First of all, we want to thank both reviewers as well as the editor for their constructive and thorough feedback on the manuscript. After having carefully addressed their valuable comments we are confident to have improved the manuscript substantially. We want to start with outlining the major changes performed:

Reviewer #1

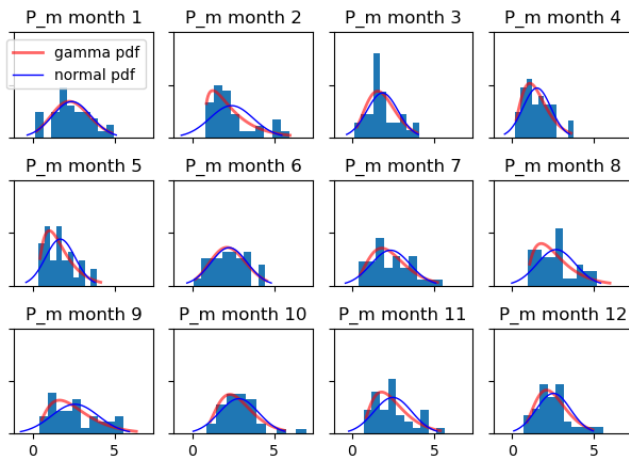
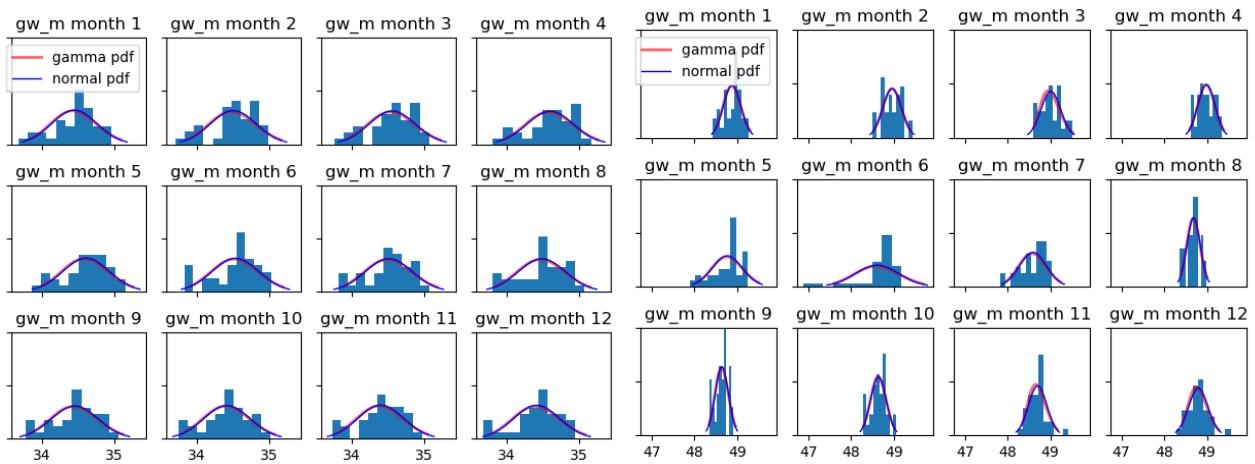
23. L290: Fitting precipitation to a normal distribution is rare. Can histograms or similar be visualized to back up the choice?

24. L290-294: Please quantitatively back up the conclusion from the Kolmogorov-Smirnov normality tests. And add the reasoning behind the choices for SDI, which is currently lacking.

Normal distribution for precipitation: Yes, that is rare. However, we find that this works for the Danish case, probably due to its relatively stable temperate climate. We performed visual checks of the data before the decision (histograms etc) and decided that even though a gamma distribution sometimes delivers a better fit, it also more prone to overfitting in these small sample sizes (n=30). One grid example for monthly precipitation is shown below:

For a row of months (Jan, Mar, Jun, Jul, Dec) the normal and gamma distribution fit are similar. For some months (especially Feb) it seems plausible that the gamma distribution delivers the better fit. For some months, Aug in this example, however, we are not certain whether the gamma distribution simply is fitting to an anomaly mostly caused by the relatively small sample size.

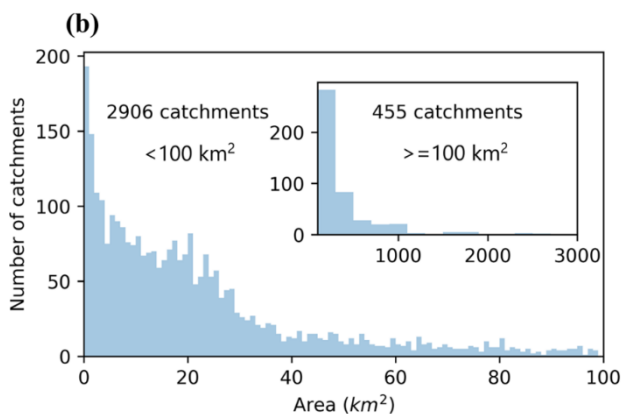
40. L413: *move interpretations of results as “good” etc. to discussion.*

As in line with similar comments, we removed these statements from the Results section (**here: line 515, but changes throughout the manuscript**)
